**GE STOCKHOLDERS' ALLIANCE,  
PATRICIA BIRNIE  
PAGE 1 OF 1**

Re: OPPOSITION TO USE OF MIXED OXIDE FUEL FOR  
 COMMERCIAL REACTORS

ATTACHMENT 3 TO GA/DOE-027-96  
ADDITIONAL GENERAL ATOMICS COMMENTS  
ON THE DRAFT PROGRAMMATIC ENVIRONMENTAL IMPACT STATEMENT  
FOR STORAGE AND DISPOSITION OF WEAPONS-USEABLE FISSILE MATERIALS

FIGURE 1 (FROM DOE/MD-0002)

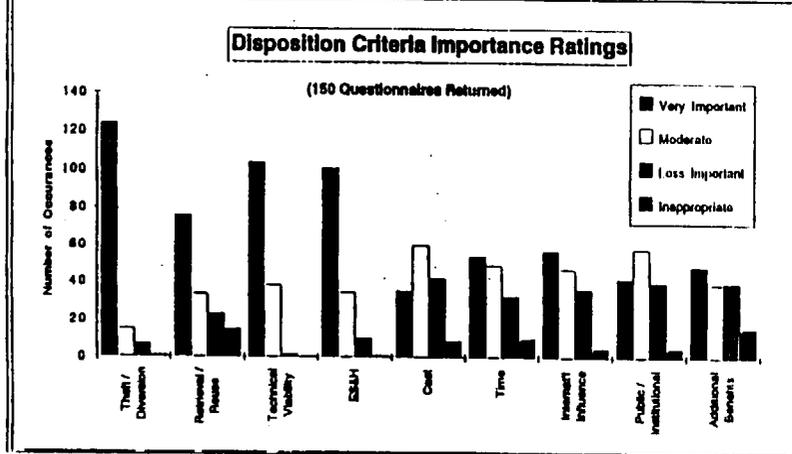
An important issue for any plutonium disposition strategy is the suitability of the final waste form for permanent disposal. Respondents to the DOE questionnaire (Ref. 7) recommended additional criteria that should be used to screen plutonium disposition technologies, including several criteria related to final waste form characteristics. During the screening process and preparation of the draft Programmatic EIS, DOE gave little consideration to final waste form characteristics and resulting long term environmental impacts, other than the annual volume of high-level waste generated by the various disposition alternatives.

Figure 1

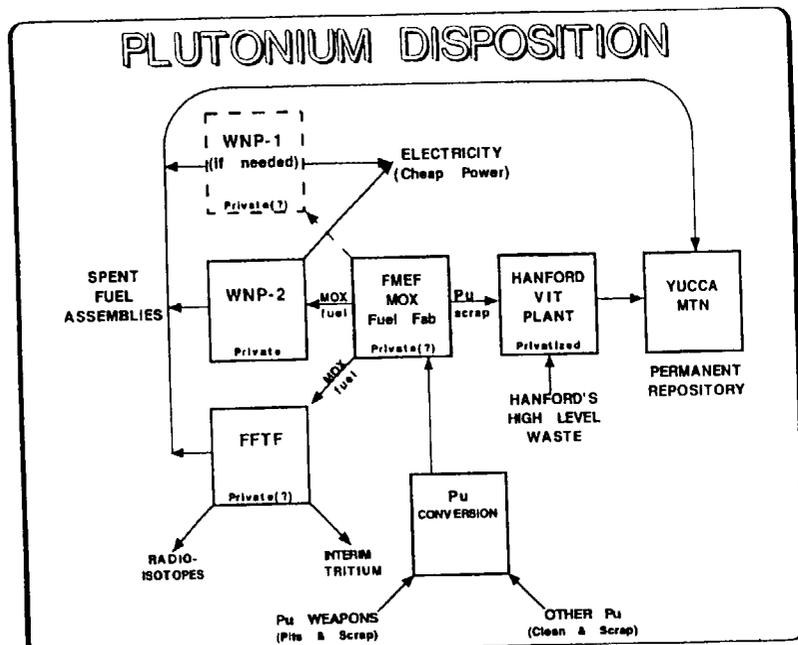
We urge you to formally and thoroughly examine the potential benefits of disposing of plutonium as depicted in the attached simplified schematic (Figure 1). We believe implementing this strategy will literally save DOE billions of dollars and shorten the time to initiate Pu disposition by at least 4 to 8 years. The schematic depicts a collocated plutonium disposition "system" involving compatible, already existing Hanford facilities plus new, already scheduled tank waste vitrification facilities. The plutonium conversion step indicated in the schematic could be at Hanford or elsewhere.

The FMEF is considered for use as a long-term storage facility for Pu, and the impacts are included in Section 4.2.1 of the PEIS. For the production of MOX fuel a generic facility was considered for all six DOE sites. At Hanford this MOX fuel fabrication facility would be located in the 200-Area adjacent to 200 East. The utilization of the FMEF would be a variant for MOX fuel fabrication at Hanford, which is bounded by the environmental analysis for the MOX fuel fabrication facility located in the 200-Area. Table 2.4-1 of the PEIS provides a brief description of variants to disposition alternatives analyzed which includes "Modification/completion of existing facilities for MOX fabrication." The storage options for Hanford also include the construction of a new facility. Utilization of the FMEF for the Upgrade Alternative would not preclude its use to also support Pu disposition activities for either Reactor or Immobilization Alternatives.
